EL PASO COUNTY GRADING AND EROSION CONTROL PLAN CHECKLIST

SPACE VILLAGE FILING NO. 4
A PORTION OF THE NW 1/4 OF SEC. 17, T14S,
R65W, OF THE 6th P.M., EL PASO COUNTY, COLORADO
GRADING & EROSION CONTROL PLAN

SPACE VILLAGE FILING NO. 4
EL PASO COUNTY, CO

SHEET TITLE:
GRADING & EROSION CONTROL
PLAN (SWMP-SITE MAP)

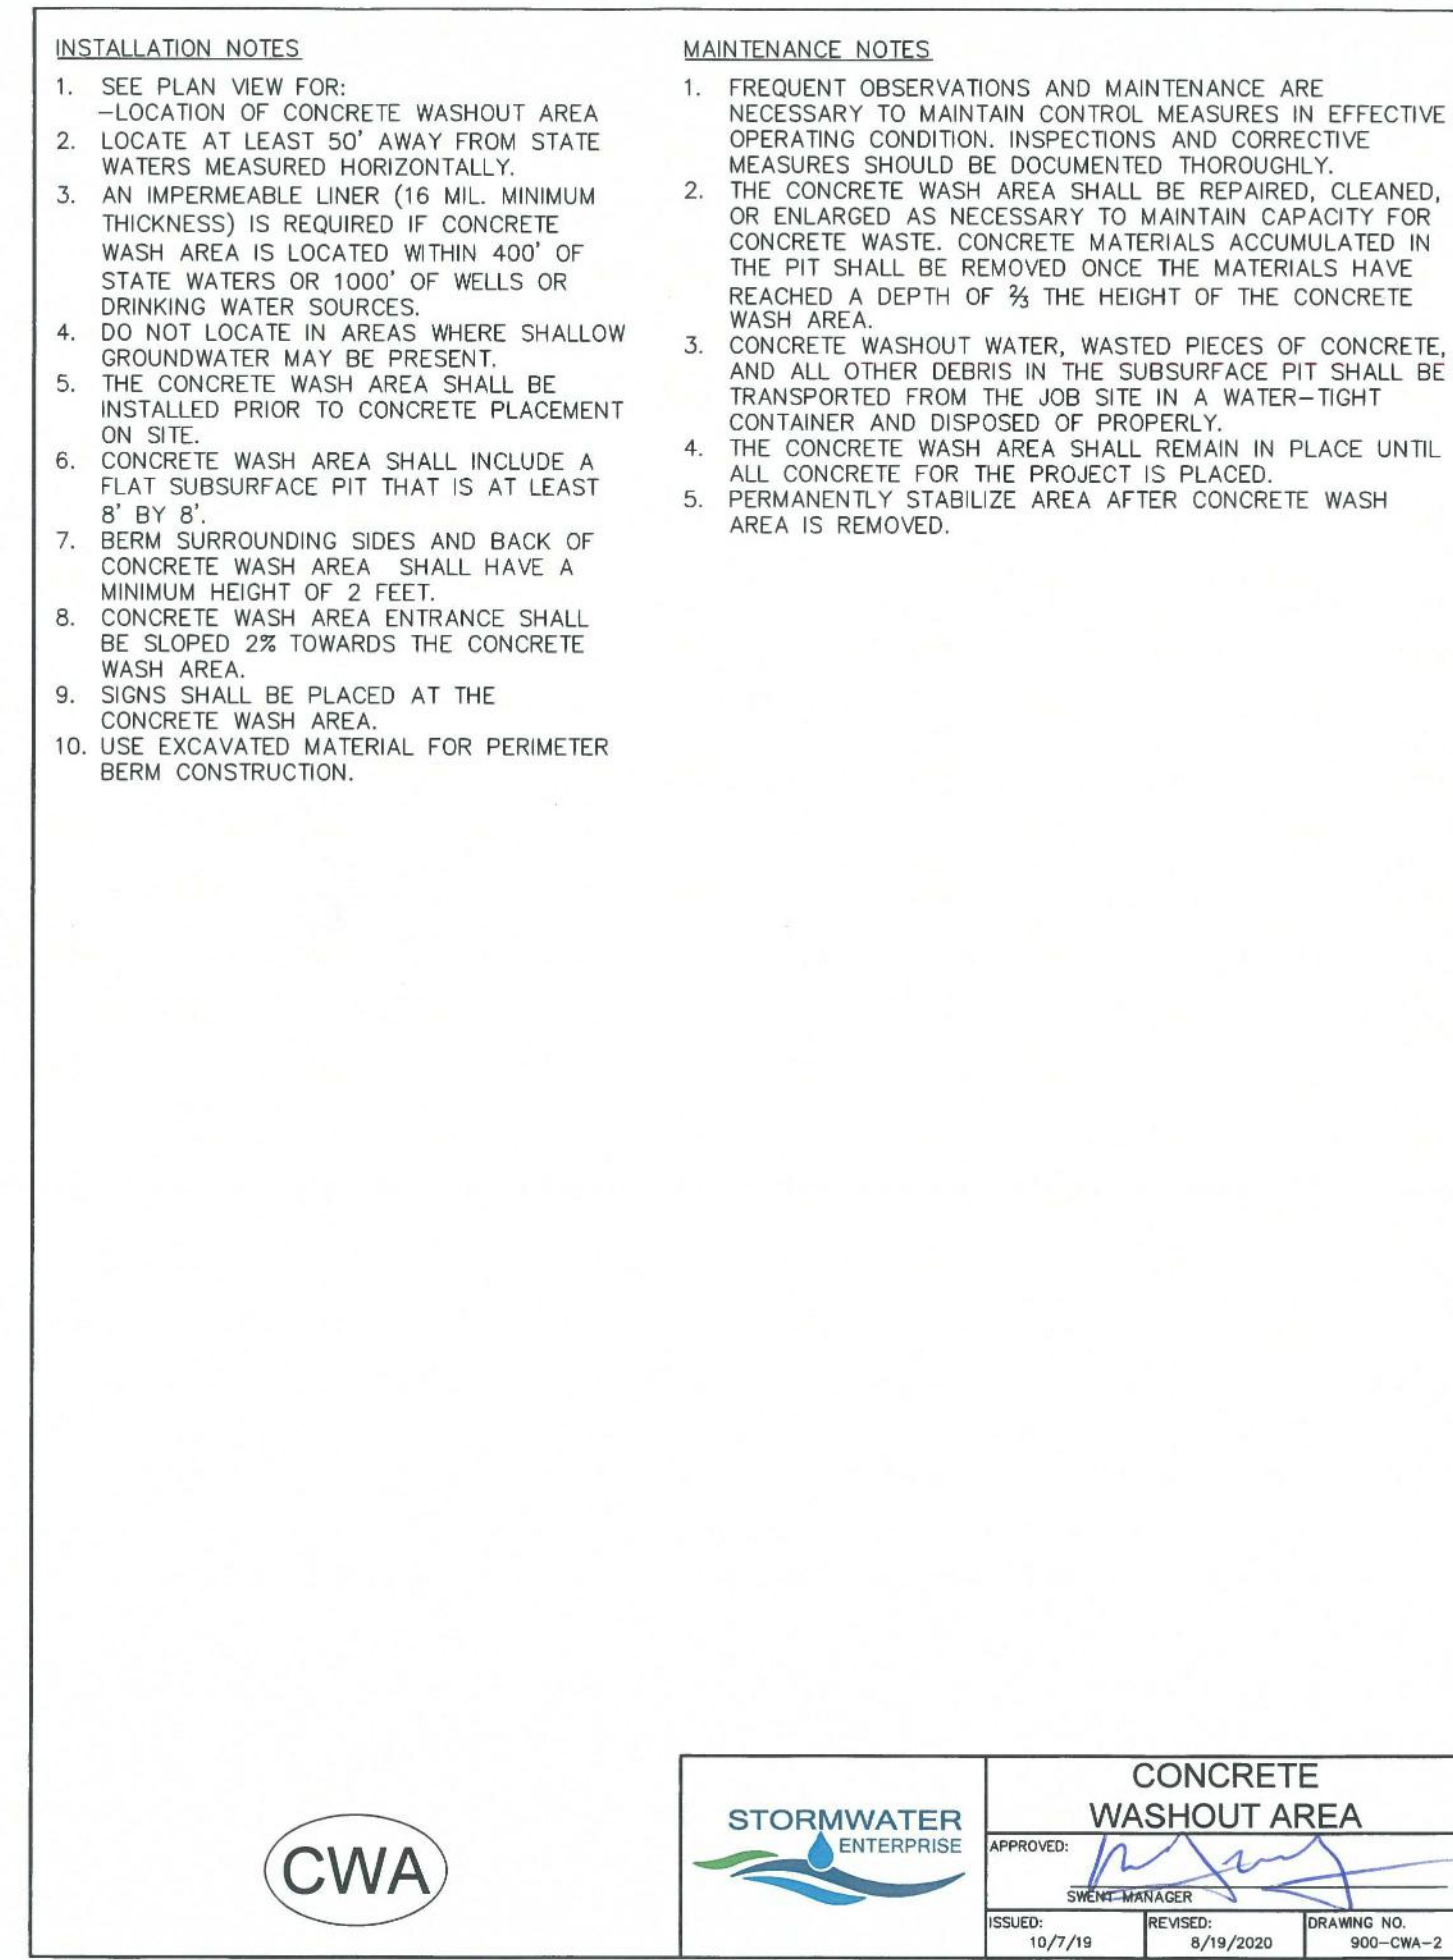
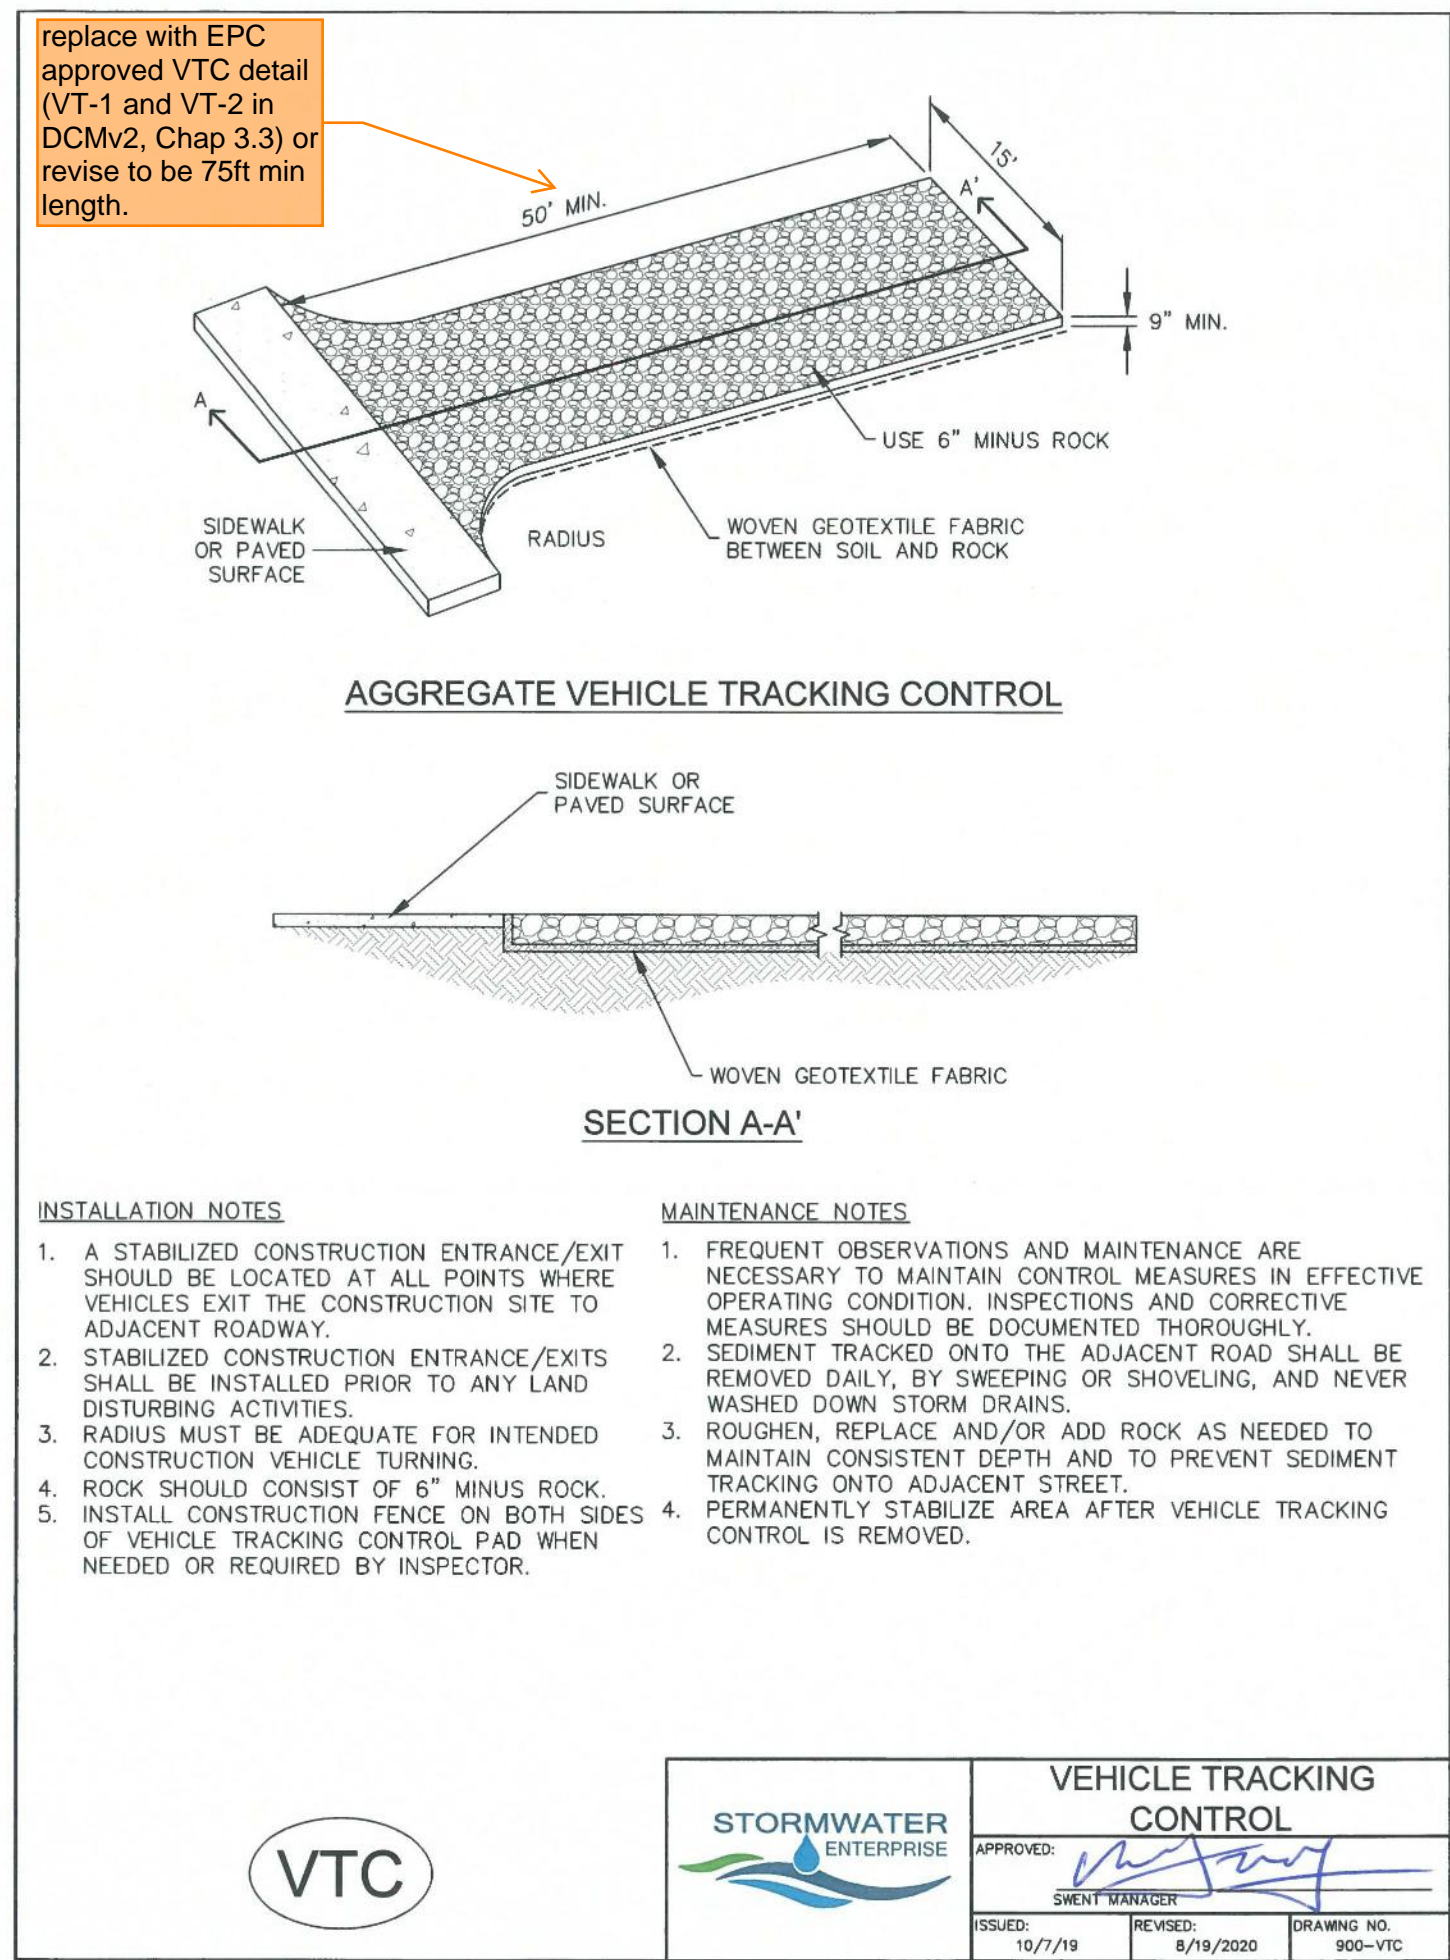
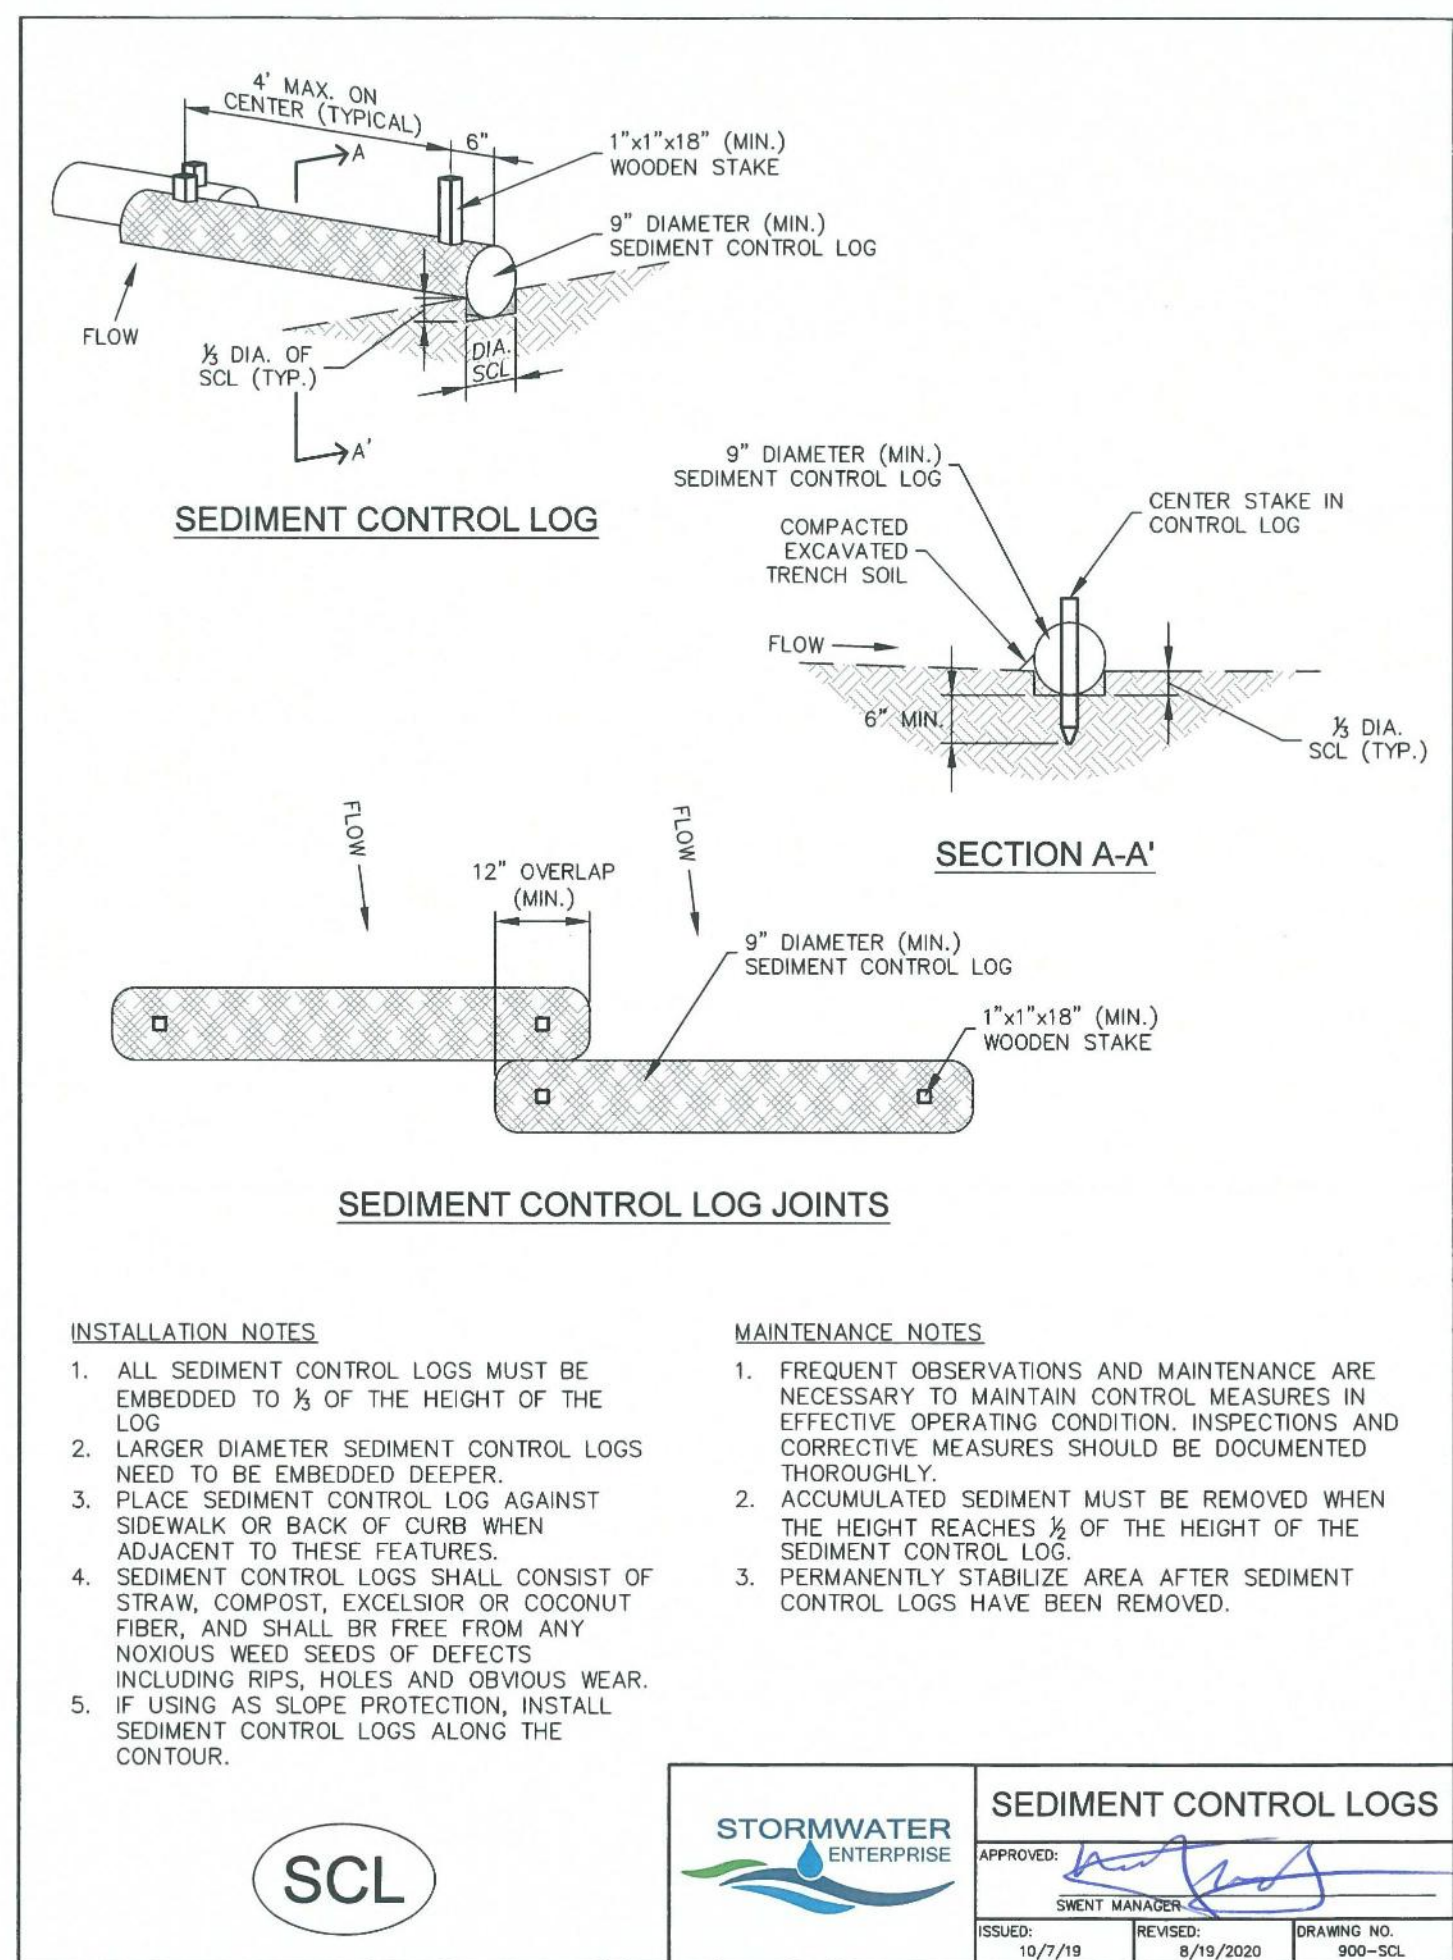
Sediment Traps are not appropriate for treating tributary areas >1ac. A Sediment Basin is for areas >1ac. Add a detail on final pages for Sediment Basin too.

Provide details for pond. To expedite the review process, I have preemptively provided our most common review comments on pond plans and details for you to consider when preparing the details:

- Emergency Spillway: provide bedding material/geotextile fabric between riprap and sub-base (per DCMv1 - Chap 10.10.5). Does not apply to spillways using soil riprap.

- Maintenance Roadway: Stabilized access ramp shall be a minimum of 15ft wide and no greater than 12% slope, in accordance with DCMv1, Chap 11.2.2. Provide roadway detail/cross section, including stone sizing and gradation. Consider using a base course that will minimize migration of fines when the pond is detaining water.

- Outlet Pipe: Per DCMv2 Section 4.3, outlet pipe should be 18" minimum.
- Pond Bottom: Pond bottom should have a minimum slope of 3% to the trickle channel and micropool (USDCM Vol 3, detail T-5). Please adjust to minimize future maintenance needs.

- Trash Rack: Trash rack to be Amico Klemp KRP Series aluminum bar grate (Figure 6-b), US Filter or Johnson stainless steel well screen with #93 VEE wire (Figure 6-a), or equivalent (per EPC DCMv2, Chap 4.3 and MHFD Detail T-12).

GEC Checklist Items H and M. If "limits of disturbance" and "construction boundary" are the same, change to "limits of construction/disturbance" or otherwise show as separate line types for each on the legend and figure.
